City of Sugar Hill
Planning Staff Report
DRB-CBD 21-004

DATE: February 2, 2022
TO: Mayor and Council, Design Review Board
FROM: Planning Director 
SUBJECT: Central Business District (CBD) Design Review
Mixed-use Development
1450 Peachtree Industrial Boulevard

SUGAR HILL II : MIXED USE DEVELOPMENT

OVERALL SITE LAYOUT PLAN

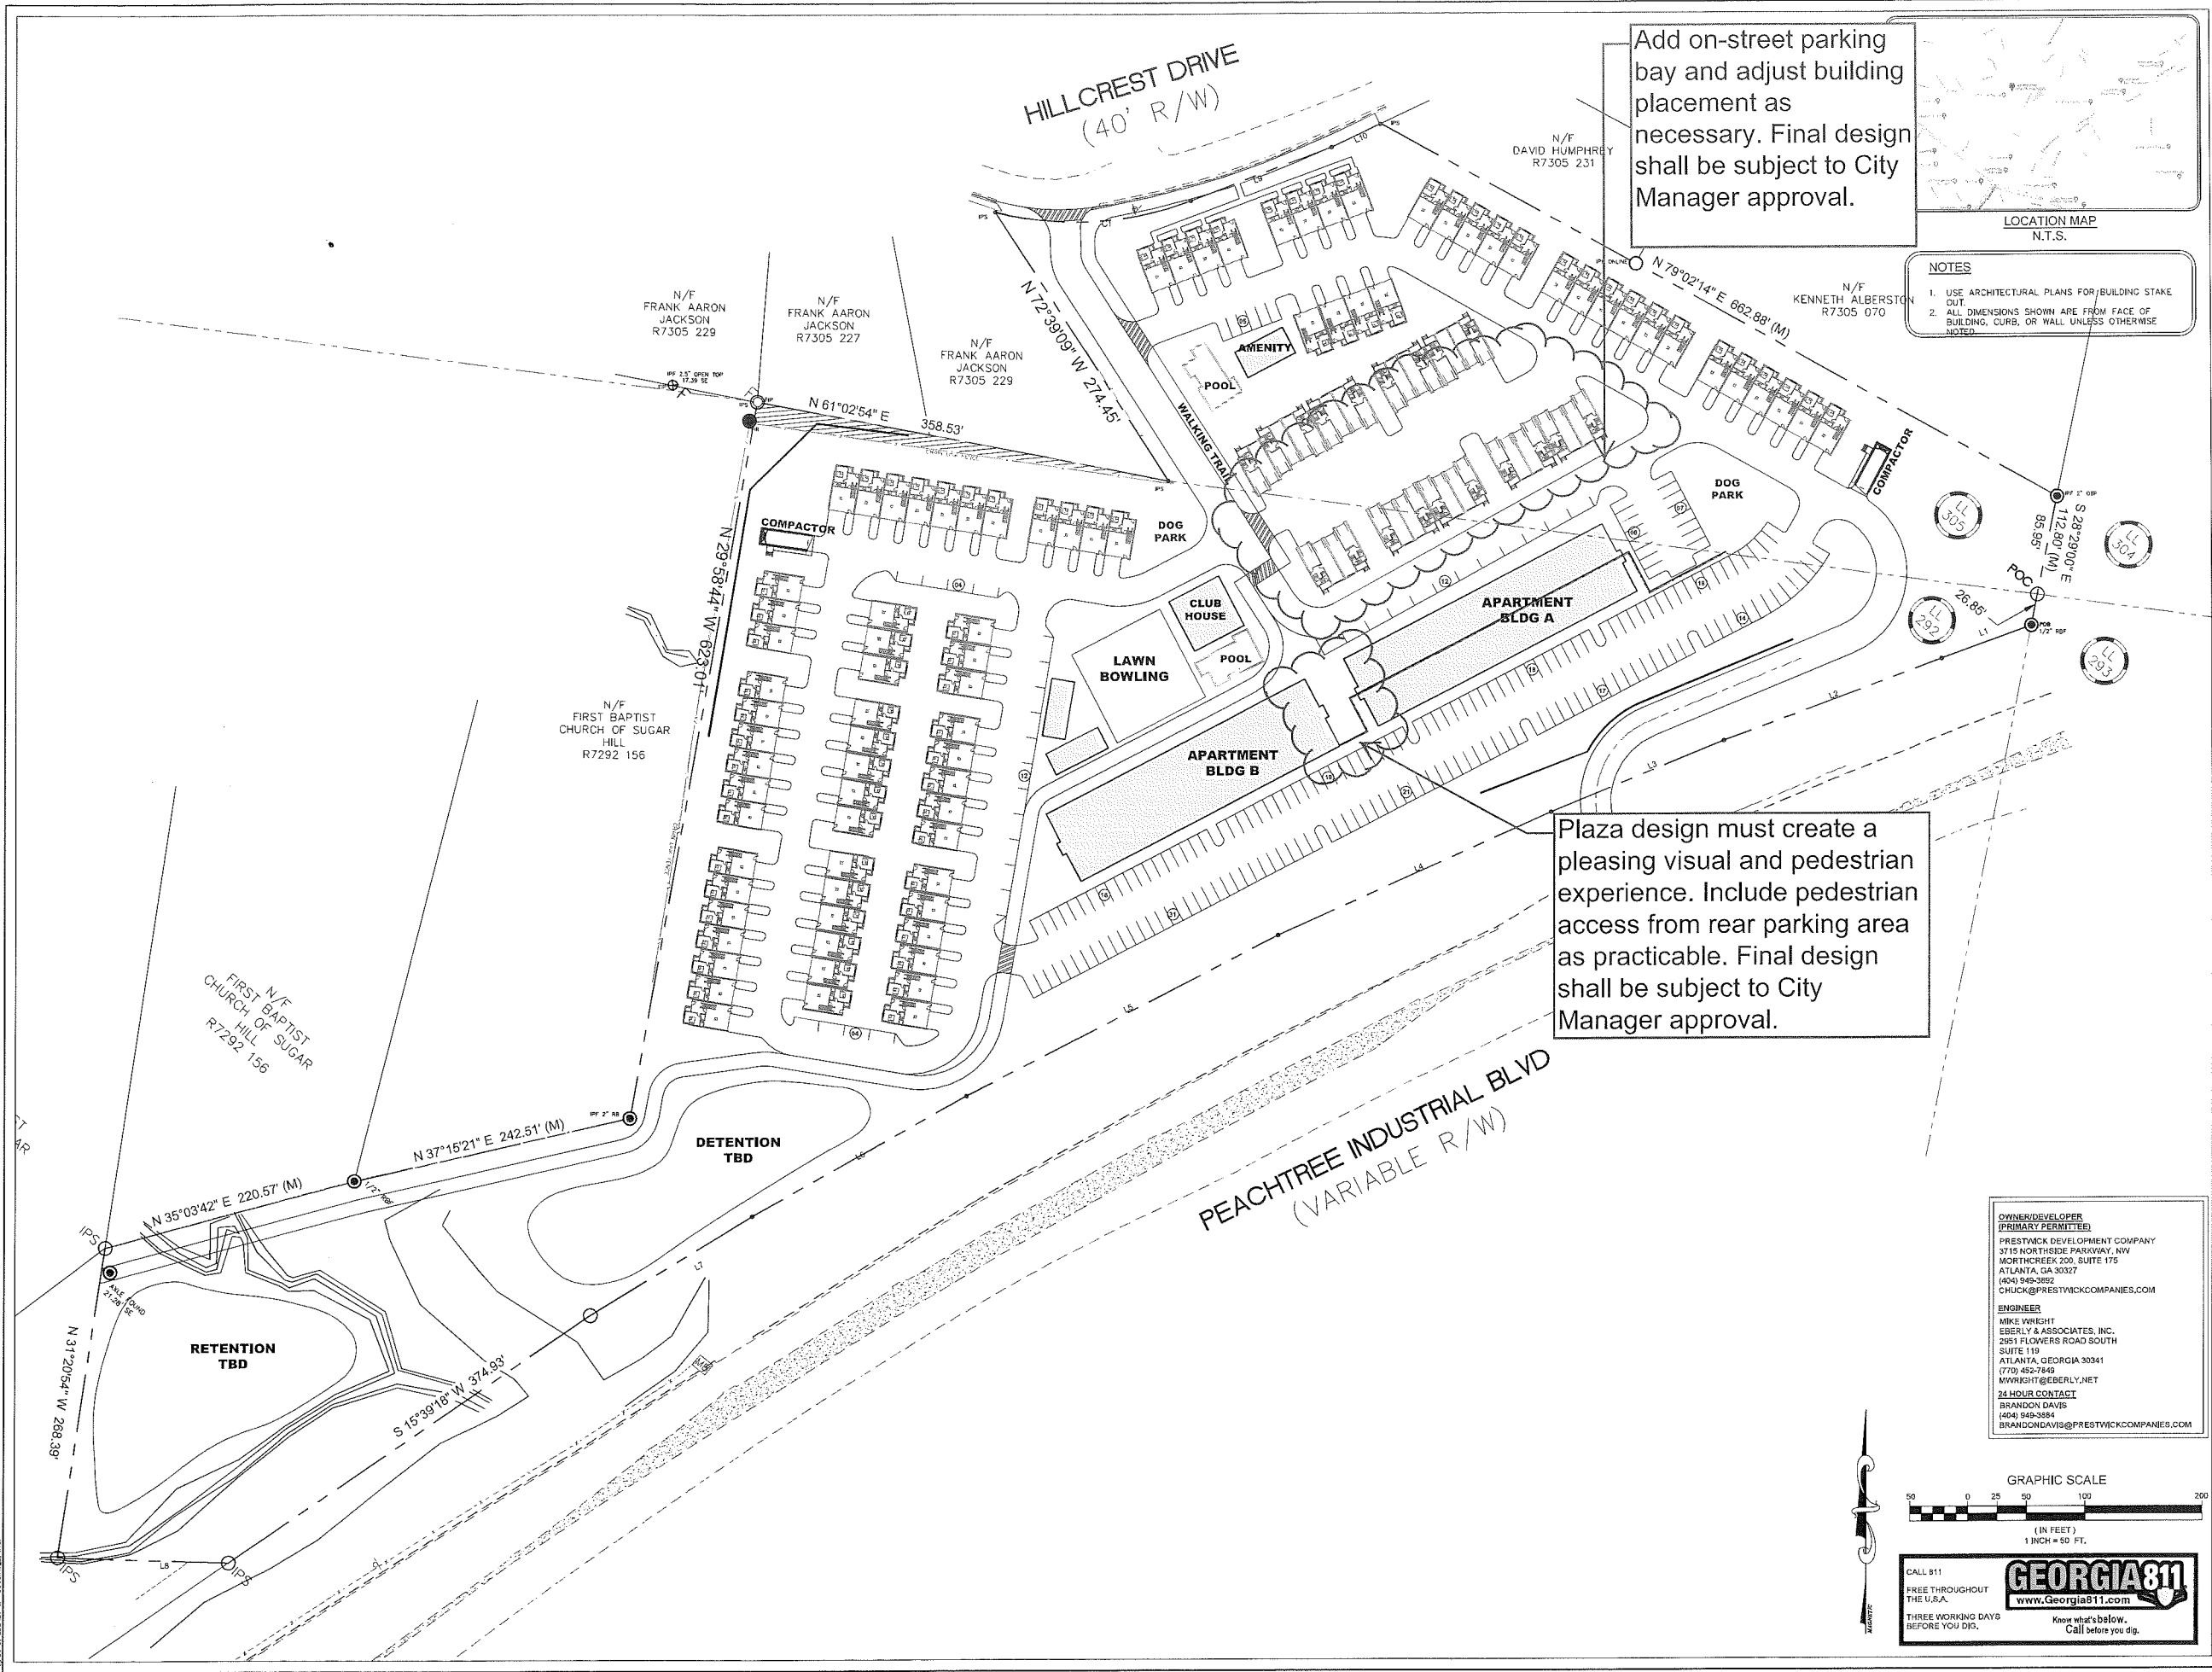
Add on-street parking bay and adjust building placement as necessary. Final design shall be subject to City Manager approval.

Plaza design must create a pleasing visual and pedestrian experience. Include pedestrian access from rear parking area as practicable. Final design shall be subject to City Manager approval.
